BEFORE THE POLLUTION CONTROL BOARD
OF THE STATE OF ILLINOIS

VILLAGE OF CARLOCK,)	
)	
Petitioner)	
)	
v.)	PCB No. 2015-110
)	(Water well Setback Exception)
ILLINOIS ENVIRONMENTAL)	
PROTECTION AGENCY,)	
)	
Respondent)

PETITIONER'S ANSWERS TO PRE-HEARING QUESTIONS

**PCB 15-110 VILLAGE OF CARLOCK
WATER WELL SETBACK EXCEPTION
RESPONSE TO PRE-HEARING QUESTIONS**

SEPTIC SYSTEM PLAN & DETAILS

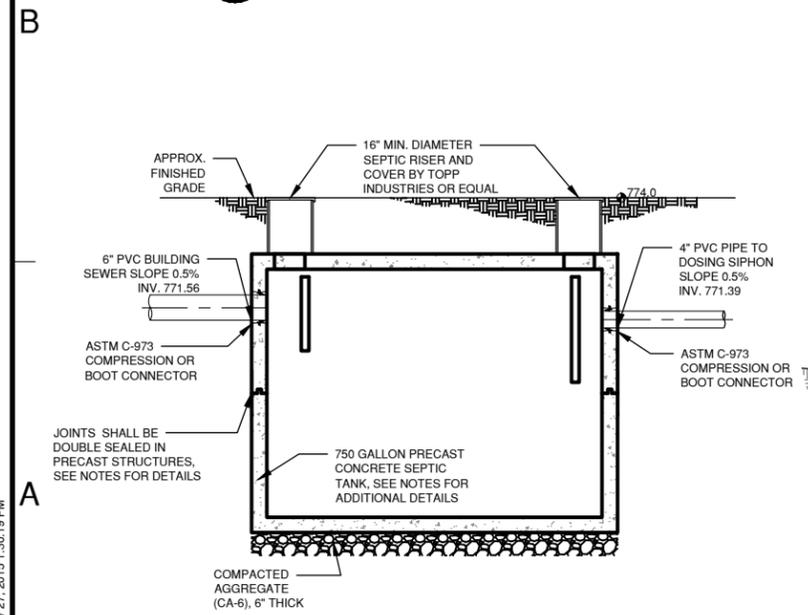
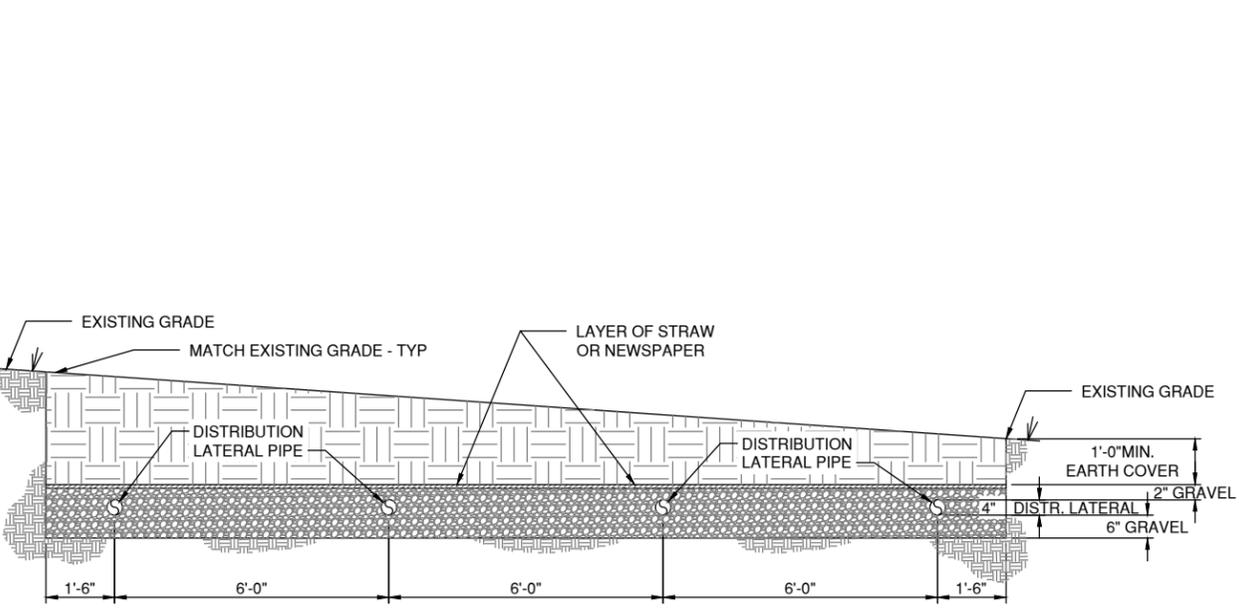
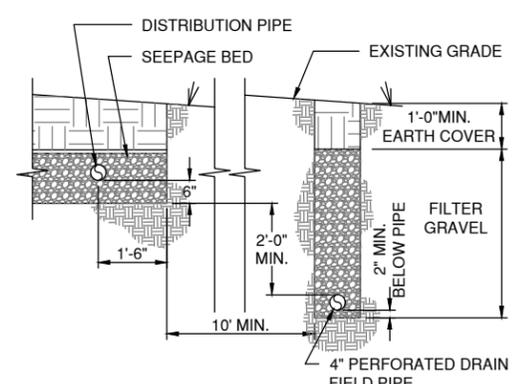
2. The proposed Septic System is a conventional septic tank system with seepage field. The Proposed Septic System was originally designed to be a septic tank followed by a sand filter. The change to the conventional septic tank system with seepage field was based on discussions with the McLean County Health Department. In the event that an aerobic system was constructed, Section 905.100(j) - Aerobic Treatment Plants and NSF International/ANSI Standard 40 Wastewater Treatment Systems of Part 905 - Private Sewage Disposal Code of Subchapter r: Water and Sewage of Chapter I: Department of Public Health of Chapter I: Public Health contains four requirements to be met for a non-residential use. With an estimated daily wastewater flow of 85 gpd, the rated capacity of the plant would not exceed 113 gpd based on the total flow to the plant being at least 75% of the rated hydraulic capacity. $(85 \text{ gpd} / 75\% = 113.3 \text{ gpd})$ With a minimum rated treatment capacity for a residential aerobic unit sized for 400 gpd, the percentage of total flow from the proposed Septic System would be 21.3% which is far less than the 75% required of the rated capacity of the aerobic treatment unit.

7. The septic tank for the proposed Septic System was required to be a minimum of 750 gallons per the liquid capacity requirements of the McLean County Health Department for flows up to 500 gallons per day. The installer placed a 1,000 gallon septic tank in lieu of the minimum sized septic tank of 750 gallons required.

8. Exhibit A of the petition is the Site Plan was drawn to scale as originally submitted. The pdf file shall be printed to its original size of 11" x 17" to be viewed to scale. An electronic copy is submitted herewith.
9. Exhibit A is being resubmitted with the approximate location of the original septic tank and seepage field shown. Please note that the septic tank and seepage field were removed/abandoned in place as necessary for the construction of the new Water Plant and as required by the McLean County Health Department.
10. Exhibit E shall be submitted as a matter of record for the details of the proposed Septic System. Please note that the Septic System permitted for use at the site has a slightly

larger septic tank and slightly smaller seepage field as shown in the attached copy of the permit application as calculated and submitted by the installer.
